Contract #: 04-0120F4Cty: SF/ALA Rte: 80 PM: 13.2/13.9File #: 69.25B**QUALITY ASSURANCE -- NON-CONFORMANCE REPORT****Location:** Changxing Island, Shanghai, PRC**Report No:** NCR-000450**Prime Contractor:** American Bridge/Fluor Enterprises, a JV**Date:** 19-Oct-2009**Submitting Contractor:** Zhenhua Port Machinery Company, Ltd (ZPMC), Changxing Island**NCR #:** ZPMC-0423**Type of problem:**

**Reference Description:** Weld repair performed without CWR on North Tower, Interior Splice Plate**Description of Non-Conformance:**

**Subject:** NCR No. ZPMC-0423

## NCR PROPOSED RESOLUTION

WELD NUMBER: NSD1-SPSA3-70-2A/B

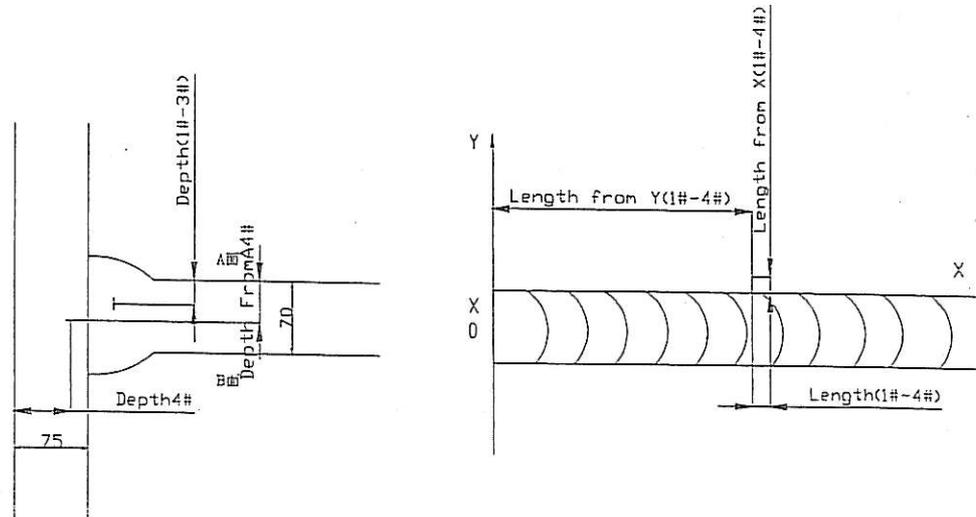
Rejected indication found by ultrasonic inspection is less than the maximum allowance aggregate length.

- 1、 碳刨后,焊接接头没有有效打磨;
  - 2、 起弧和收弧没有交错布置,以将焊渣减少到最少;
  - 3、 焊道间没有有效的清理.
- 1.The weld joint was not ground sufficiently after arc-gouging.
  2. The arc starts and stops were not staggered to minimize slag entrapment.
  3. Interpass cleaning was not performed properly.

- 1、 Gouge off the defect weld;
  - 2、 Grind smoothly the gouged surface;
  - 3、 If User's request ,check with MT or other NDT method to make sure the defect remove compelety;
  - 4、 Preheat and the interpass temperature control according to the relative WPS-repair;
  - 5、 Check the welding according to the approved shop drawing.
- 1、 请将有缺陷的焊缝碳刨去除;
  - 2、 将碳刨处打磨光滑;
  - 3、 如用户要求,用 MT 或其它的无损检测方法证实缺陷被完全清除;
  - 4、 按批准后返修焊接工艺规程 WPS 要求进行预热和控制道间温度;
  - 5、 按图纸要求检测焊缝
